# Metropolitan Planning Commission

Staff Reports

March 8, 2012

Project No. Subdivision 2012S-019-001
Project Name Beaumont Place Resubdivision

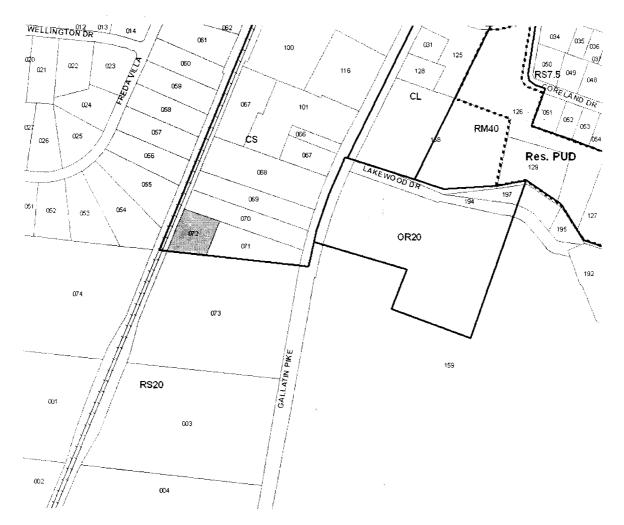
The required sidewalks on Benjamin Street are not shown on the plat and no request for a variance for the sidewalks has been received. The applicant was given three options to accommodate the sidewalk:

Sidewalks need to be included on the plat or a variance to Section 3-8.2 requiring sidewalks on existing streets needs to be requested by the applicant and granted by the Planning Commission.

As noted above, the applicant has not requested any variances as required by Section 1-11.2. As there appears to be a number of lots of similar shape and size in the immediate area, the applicant will need to demonstrate that the conditions for the variance are unique to this property and not applicable to other property as required by Section 1-11.1.b.

As the notices for this request had been mailed, it was placed on the February 9, 2012, agenda. The Planning Commission deferred at the request of the applicant. Staff is recommending deferral of this item in order for the Water Services review to be completed. If the applicant does not agree to the deferral, staff recommends disapproval of this plat as the applicant has not met Water Services requirements for plat review and the plat does not does not meet the requirements for Sections 3-5.2.b (Infill Subdivisions) and 3-8.2 (Requirements for Sidewalks.)

- 1. All required capacity fees shall be paid and any infrastructure required by the Water Services Department shall built and accepted, or bonded prior to the recording of the plat.
- 2. Prior to the recording of this plat, one of the following options must be implemented:
  - a. Submittal of a bond application and posting of a bond with the Planning Department for the sidewalk;
  - b. Construction of sidewalk and including its acceptance by Public Works; or
  - c. The addition of the following note to the plat: "No building permit is to be issued until the proposed sidewalk is constructed per the Department of Public Works' specifications."

Project No. Zone Change 2012SP-007-001
Project Name Dollar General Stewarts Ferry

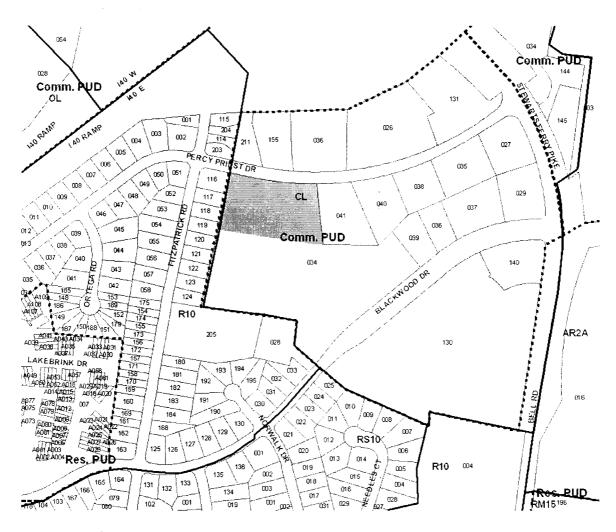
buffers is not permitted by Metro Stormwater regulations. The applicant has applied for a variance to the Metro Stormwater Management Committee to permit development within the floodway buffers. A similar variance was approved by the Stormwater Management Committee with the previous SP from 2007. The current SP proposal would require a smaller buffer encroachment than what was approved under the currently-approved SP. The applicant proposes substantial tree planting within the buffer as mitigation to the disturbance of the floodway buffers.

A signage plan and signage standards were not addressed in the SP proposal. The retail use will likely include a proposal for a ground sign. Any ground signs for the proposed use shall have a maximum height of 6 feet with a maximum display surface area of 36 square feet.

- Show undisturbed buffers (or provide variance).
- Add Buffer Note to plans:

- 1. Ground signs shall have a maximum height of 6 feet and a maximum display area of 36 square feet.
- 2. The proposal shall comply with comments listed above from Metro Public Works and Metro Stormwater.

- 5. For any development standards, regulations and requirements not specifically shown on the SP plan and/or included as a condition of Commission or Council approval, the property shall be subject to the standards, regulations and requirements of the MUL zoning district as of the date of the applicable request or application.
